Temporary Windshield Fogging After Blower Start-Up – Install Revised Control Module

MODEL 1995 MY  
Sedan Range  
VIN  
720001 - 741196

ILLUSTRATION 1

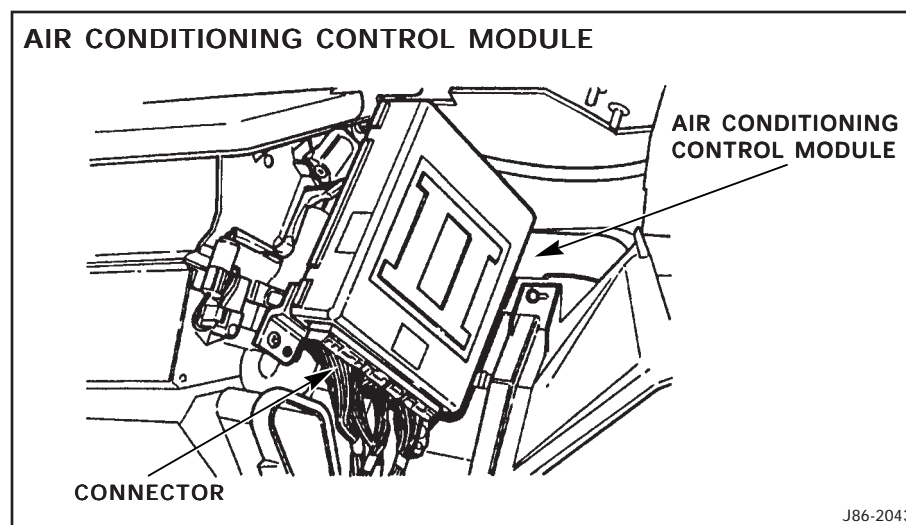
Temporary fogging of the windshield after blower start-up may occur on some Sedan Range vehicles within the above VIN range. The condition results from residual moisture in the A/C unit reaching the windshield through the defroster ducts.

A revised Air Conditioning Control Module (A/CCM) entered production as of VIN 741197. This control module delays the opening of the defroster ducts for 30 seconds after the blower motors start to allow any residual moisture to evaporate.

In case of a customer complaint of temporary windshield fogging after blower motor start-up on Sedan Range vehicles within the above VIN range, replace the A/CCM with the revised module part no. LNA 7600AF.

1. Disconnect battery negative cable.
2. Remove the right side dash liner and the right side footwell outlet duct.
3. Disconnect the A/CCM harness connectors (Illustration 1).
4. After removing the screws, remove the A/CCM (Illustration 1).
